<b>A17</b>	BT00.00-X-1000Z	<b>Technical modifications</b>	<b>11.12.98</b>
------------	-----------------	--------------------------------	-----------------

**Production breakpoint data/Modifications/New features**

<b>D17</b>	BT35.31-P-0013-01A	Radial seal ring on side of rear axle housing and connecting flange modified	as of 01.04.98	 <b>BT</b>
------------	--------------------	--	----------------	---

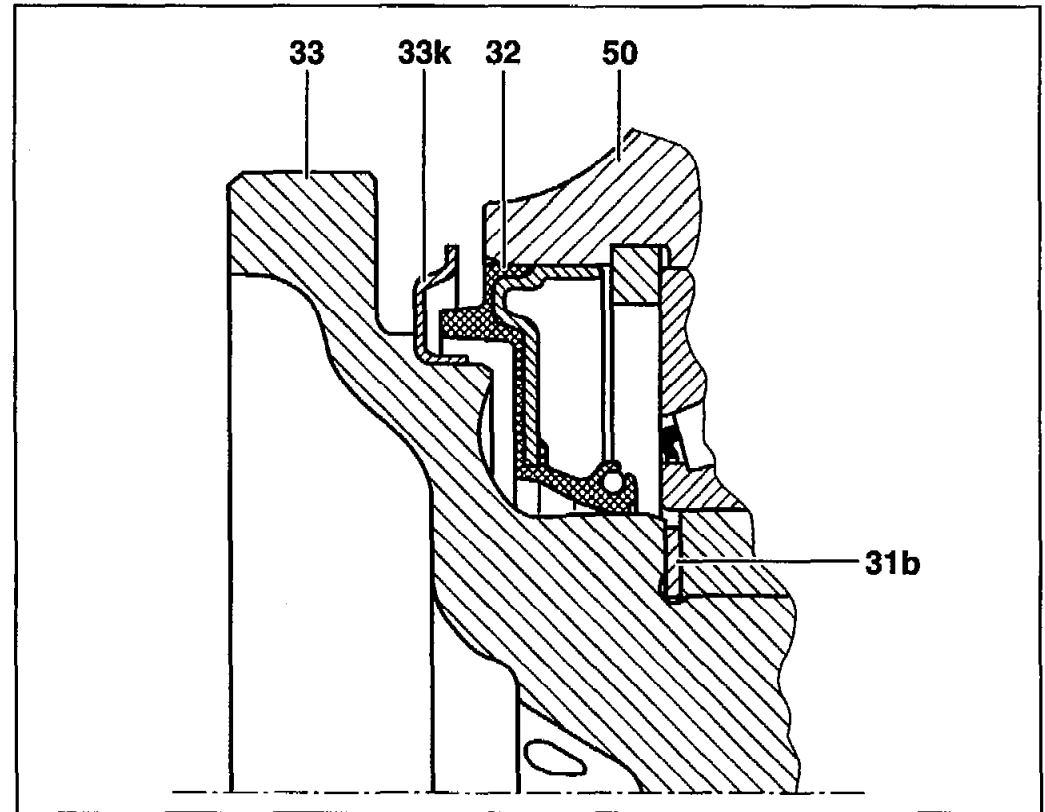
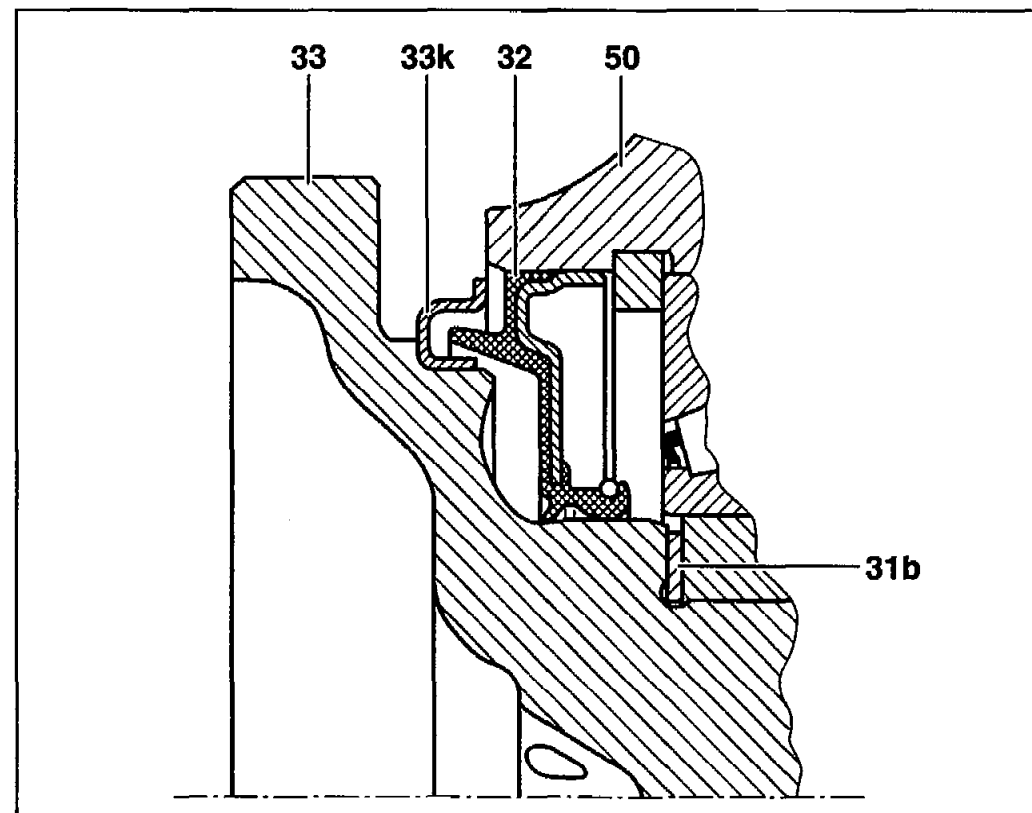
A new radial seal ring and new connecting flange with protective ring has been fitted, phased in as of 01.04.98.

This improves the sealing at the connecting flange against dirt from outside.

When installing the new connecting flange, it is essential to install the new radial seal ring as well. This is the only way to ensure correct sealing

When the new radial seal ring is installed, the previous connecting flange can continue to be installed.

<b>G17</b>	BT35.41-P-0002-01A	Routing of ASD ring cylinder and hydraulic pipe modified		
------------	--------------------	--	--	--

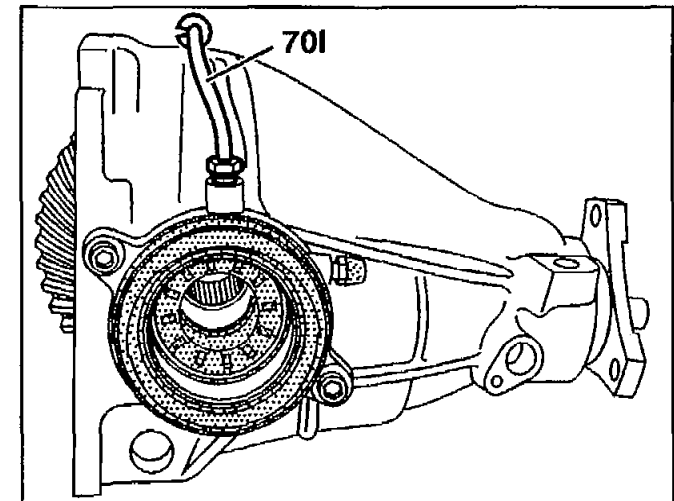
Right-hand hydraulic pipe connection modified to improve access when bleeding.

The second version of the ring cylinders are marked on the connection with "R" for right-hand side and with "L" for the left-hand side. When converting the first version to the second version the hydraulic pipe (70l) is to be replaced at the same time.

*Location of 2nd version of pipe routing on right-hand side only, breather connector arranged horizontal*

H17 BT35.31-P-0012-01A	Radial seal ring and joint flange on drive pinion modified		 BT
---------------------------	--	--	--

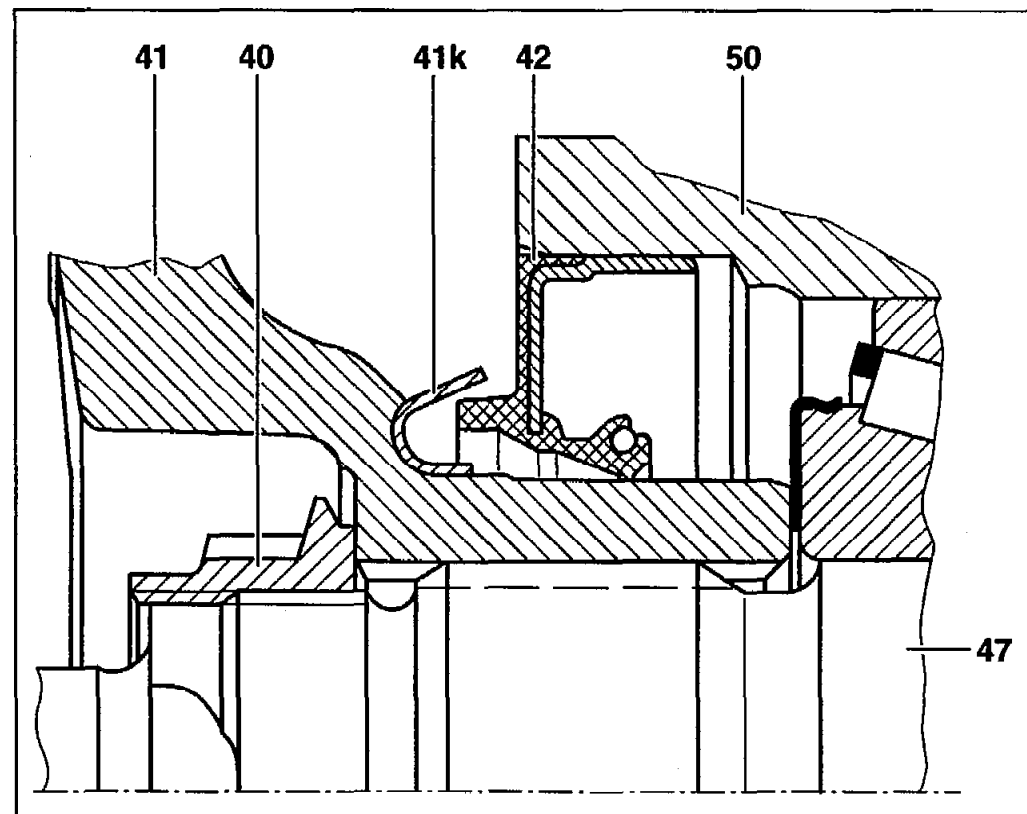
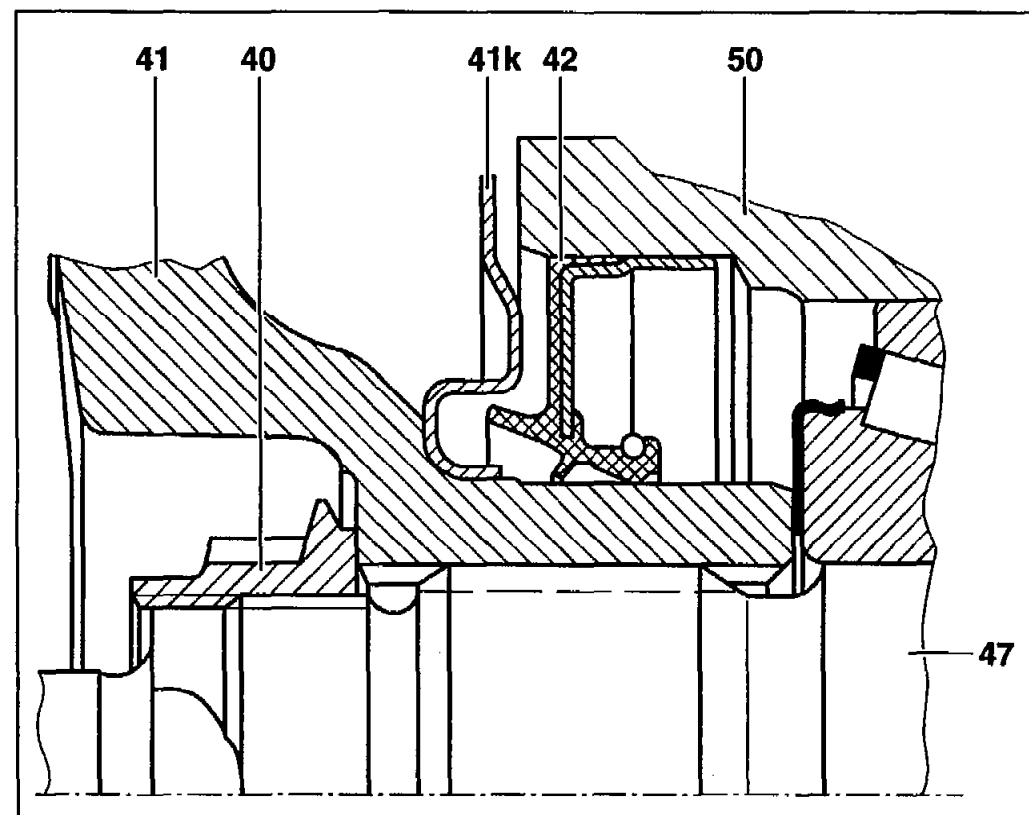
A new radial seal ring and new joint flange with protective ring has been fitted, phased in as of 01.04.98.

This improves the sealing on the drive pinion against dirt from outside.

When installing the **new joint flange**, it is essential to install the **new radial seal ring** as well. This is the only way to ensure correct sealing

When the new radial seal ring is installed, the previous joint flange can continue to be installed.

<b>M17</b>	BT35.31-P-9402-01A	Integrated thrust washer on tapered roller bearing inner race		BT
------------	--------------------	---	--	----

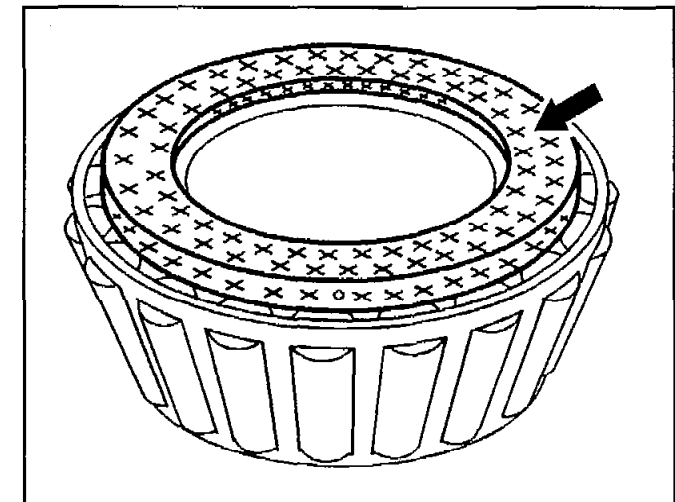
The thrust washer is permanently integrated on the small tapered roller bearing inner race of the drive pinion to facilitate assembly.

**i** The thrust washer was clipped onto the tapered roller bearing inner race with 3 retaining lugs on the previous version.

<b>B18</b>	BT35.31-P-0009-01A	Connecting flange with centering	<b>BT</b>
------------	--------------------	----------------------------------	-----------

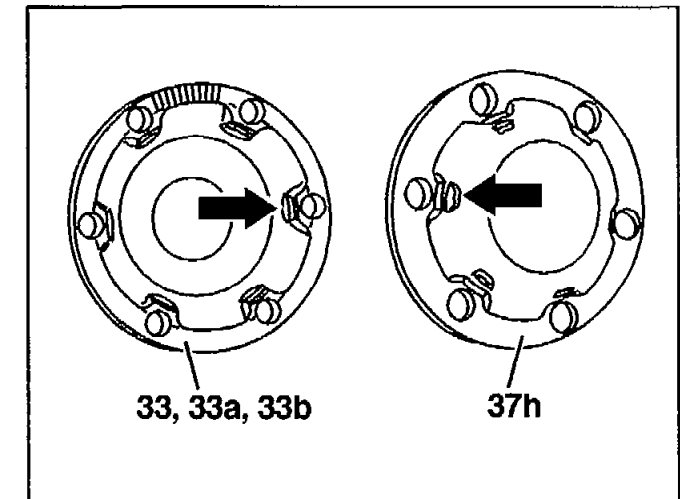
**Connecting flange with centering.**

The connection between the flange (33, 33a, 33b) and rear axle shaft has been made more accurate and the concentricity has been improved. The connecting flange (33, 33a, 33b) has turned surfaces and the end cover (37h) of the rear axle shaft has impressions (arrows).
